Examination of WHVC slope

Purpose

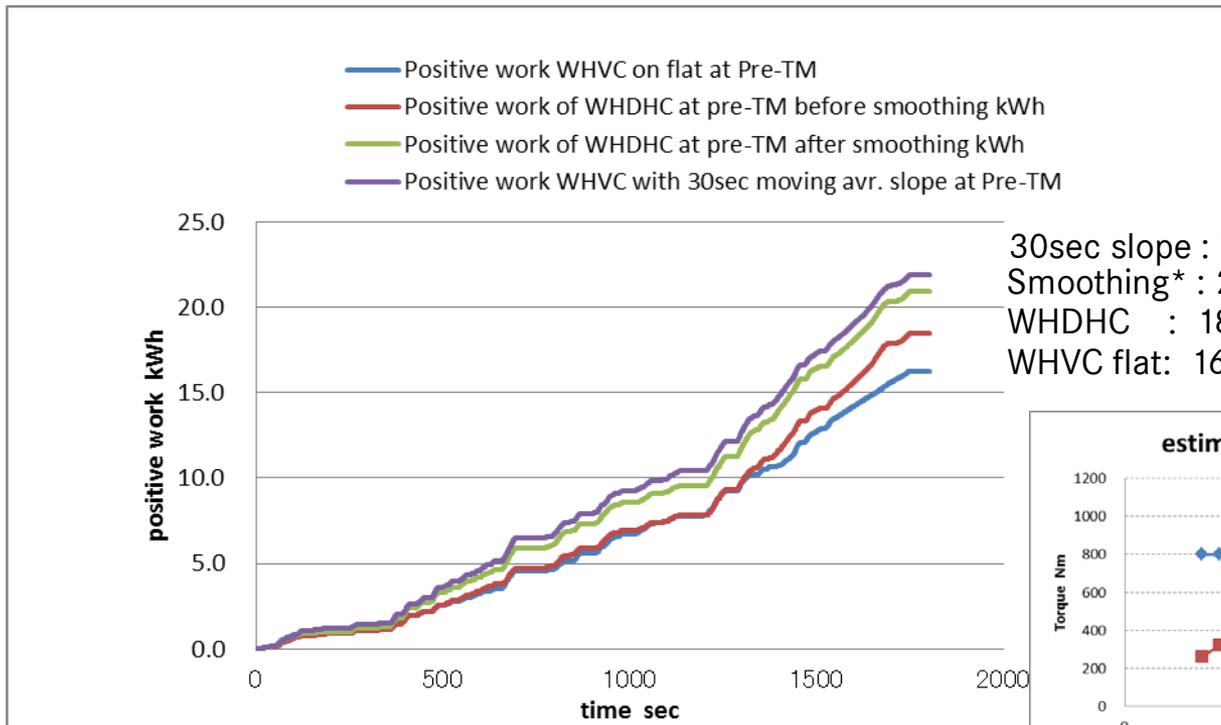
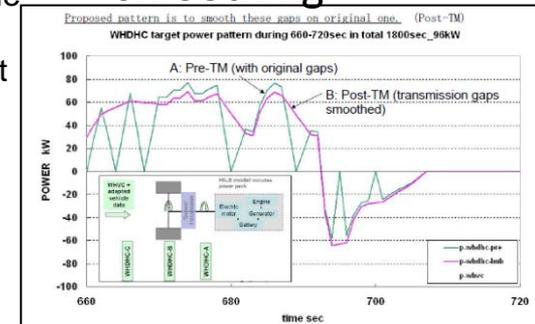
The figure below shows the positive total work in time history in HDH-14-04e, page 10. The measured work in WHVC with 30 sec moving averaged slope was about 25.5 kWh, exceeding by 38% the calculated work in averaged WHTC of 18.43 kWh*, the targeted reference.

30sec moving averaged slope: c.a. 25.5kWh
↑ +38%
Averaged WHTC: 18.43kWh

Mini-cycle works perfectly on the first 11 cycle. Can't follow during the last cycle. 30s moving average slope fails. It was hard to follow by the driver and chassis dyno and gives wrong work.

Fig.2 comparison of positive work Pre-TM

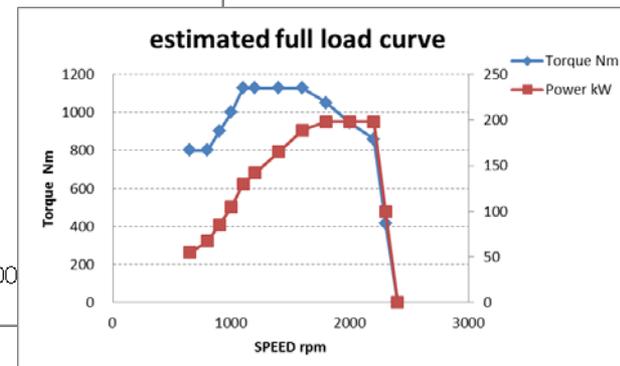
In comparison of all calculated results, the positive total work in time history showed that the value in 30 sec moving averaged slope deviated from WHDHC by 18.5% (Fig. 2). What caused the deviation was the smoothing upon zero gaps by gear shifting to the target power pattern* (+13.2%) and mathematical error in the process of the conversion from instantaneous (second by second) slope into moving averaged one (+4.8%).

30sec slope : 21.9kWh
 Smoothing* : 20.9kWh
 WHDHC : 18.4kWh
 WHVC flat: 16.2kWh

Fig.6-1 Actual speed pattern and comparison of positive work

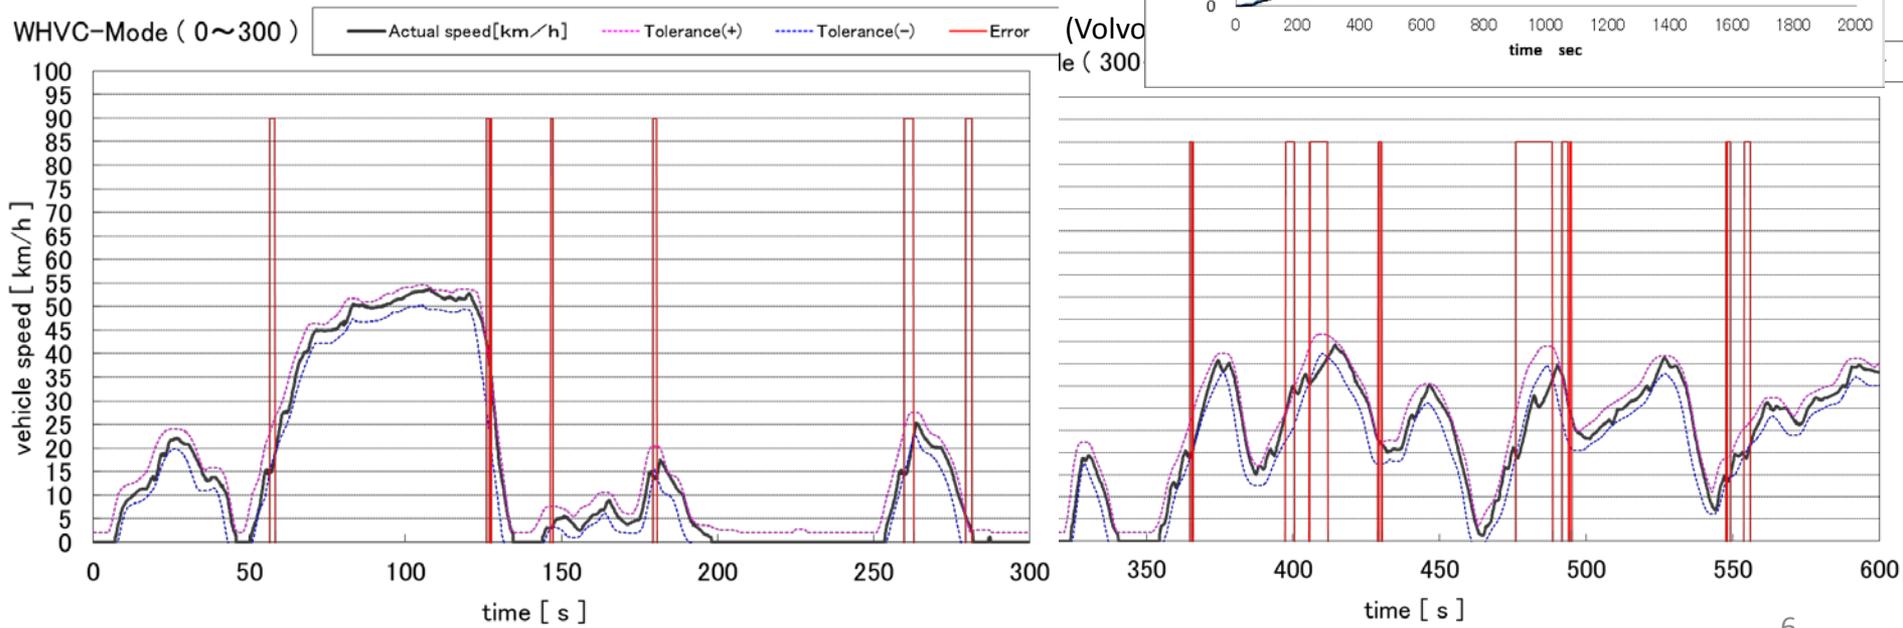
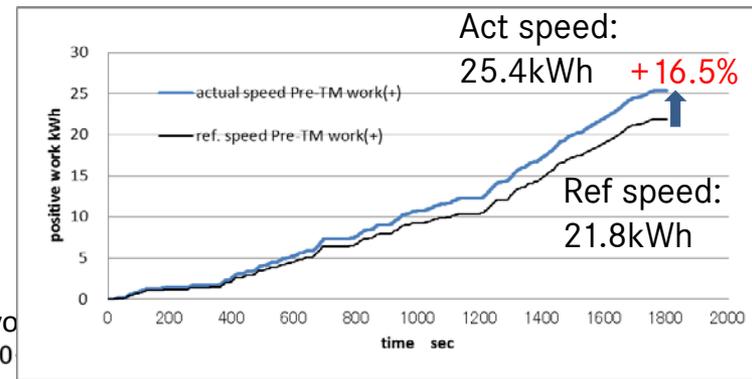
Based on the data on vehicle speed actually measured by JRC in its chassis dyno test provided by the institutes, we compared calculating positive cycle works on a 30 sec moving averaged slope by actual vehicle speed pattern or targeted vehicle speed pattern. We found that work in actual vehicle speed pattern increased by 16.5%.

A possible cause is that, since gear shifting time is long, the vehicle speed rapidly accelerates after gear shifting to make the vehicle run within the limits of tolerance. Another factor might be many times of out of tolerance. (Fig. 6).

time range for the total cumulative value of time deviations	181.7
max. time range for one deviation	12.5

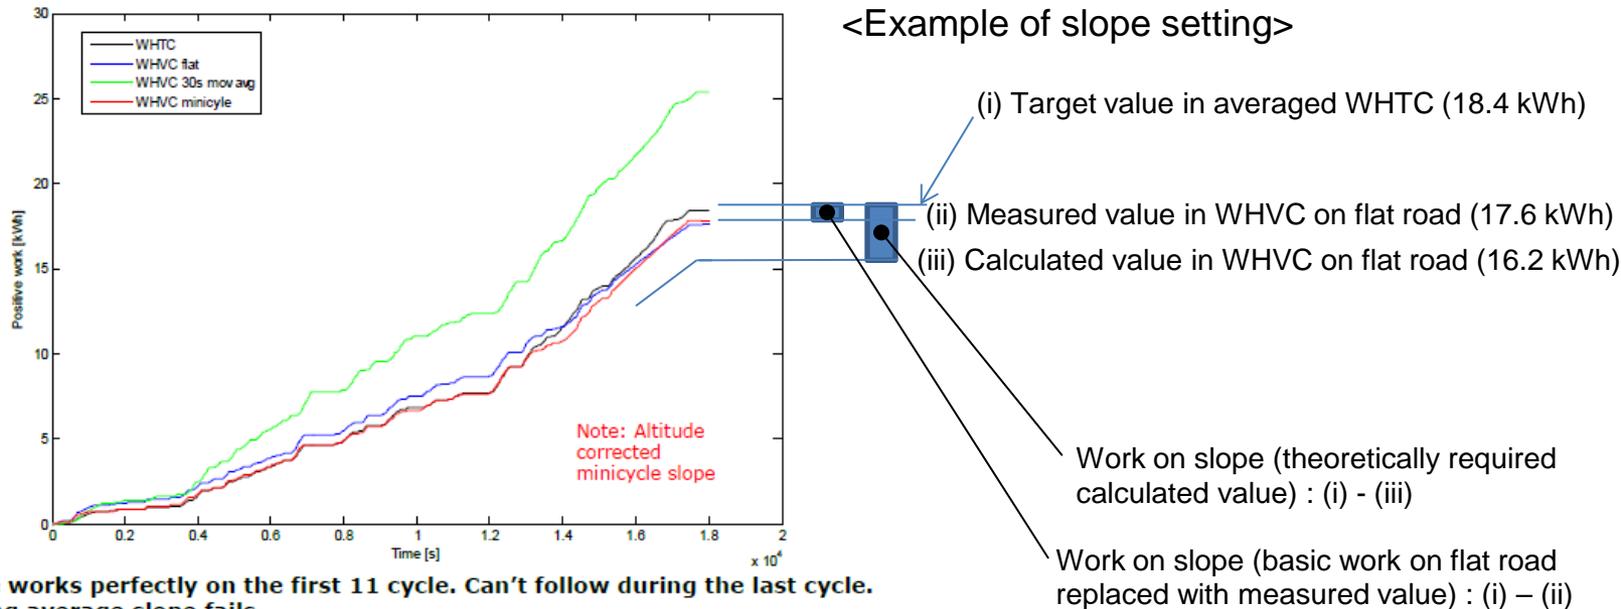
Whether smoothing is technically necessary or not is yet to be reconsidered, but, if smoothing is done, it would be more reasonable to use reference values after smoothing. This means that, when properly compared, positive cycle work should be compared between an actual work of 25.5 kWh and targeted value of 20.9 kWh for WHDHC with smoothing. The result is that actual work is higher than target work by 22% (Fig. 7).

This may be explained by the limited ability of the actual vehicle speed closely following the target vehicle speed (+16.5%) and mathematical error in the 30 sec moving averaging process. (+4.8%).

Mini-cycle works perfectly on the first 11 cycle. Can't follow during the last cycle. 30s moving average slope fails. It was hard to follow by the driver and chassis dyno and gives wrong work.

Fig. 12 Zero gaps disappear with moving average

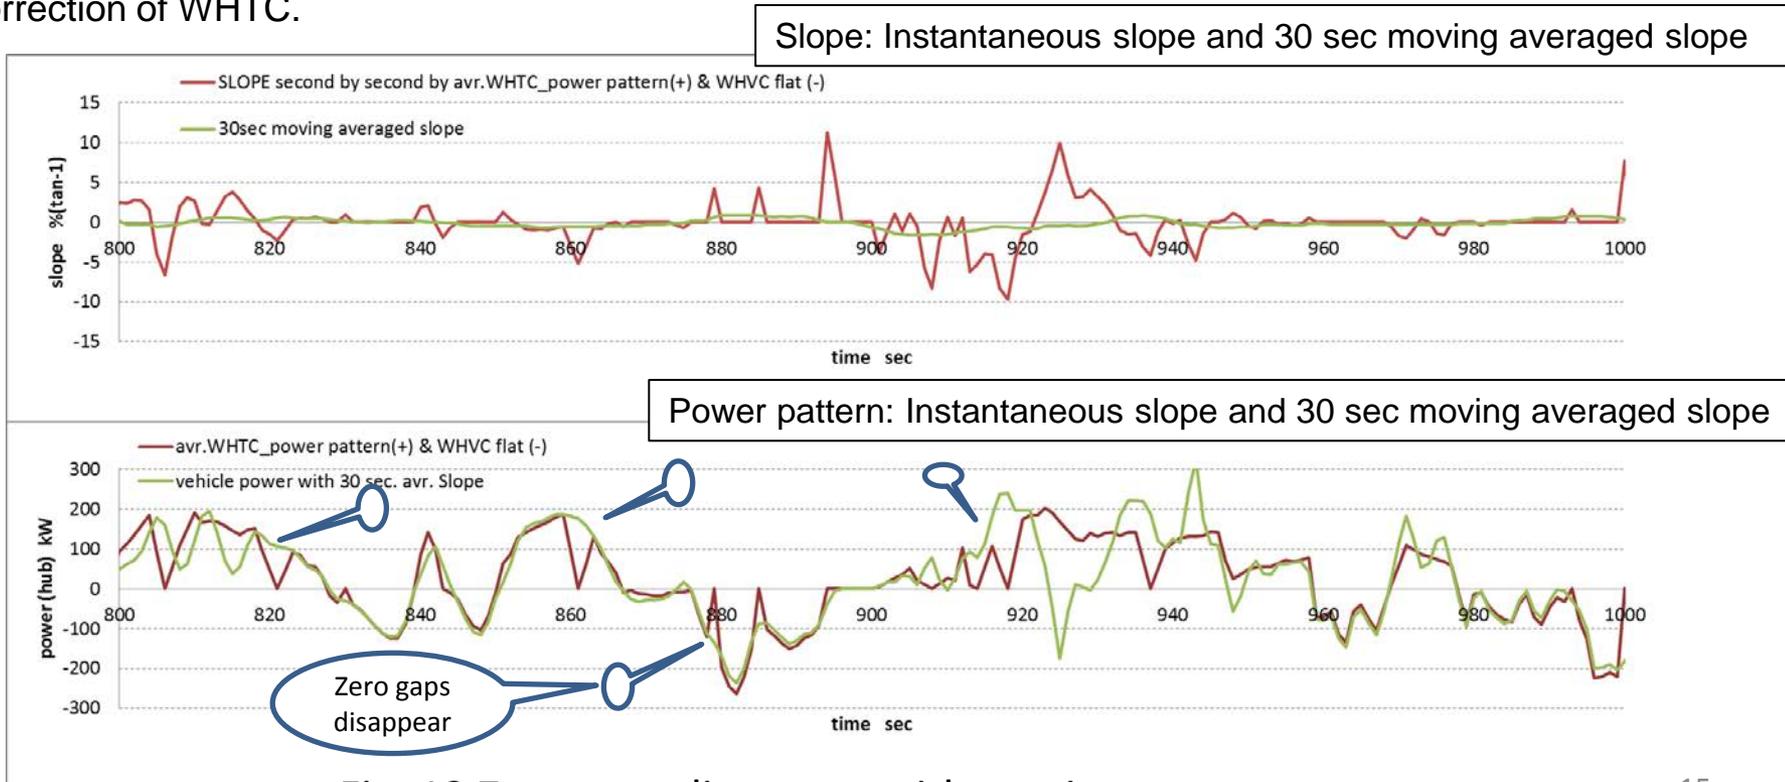
Just as WHTC, the averaged WHTC keeps the zero torque gaps from gear shifting. This gap is produced when the engine clutch is disengaged. So, in principle, while running with the clutch engaged, we should not reproduce this in such a way that the engine load goes down to zero by giving instantaneous up-hill slope. On the other hand, it is nevertheless not reasonable, either, to always disengage the clutch and shift the gear at this timing. That was why we proposed smoothing (filling) the gap.

After reexamining the issue, however, we decided to withdraw our proposal considering that: For the 30 sec moving averaged slope, we can eliminate the gap by using moving average (Fig. 12); In the mini-cycle, the slope is constant for each peak and the gap is not reproduced; It is desirable to minimize the correction of WHTC.
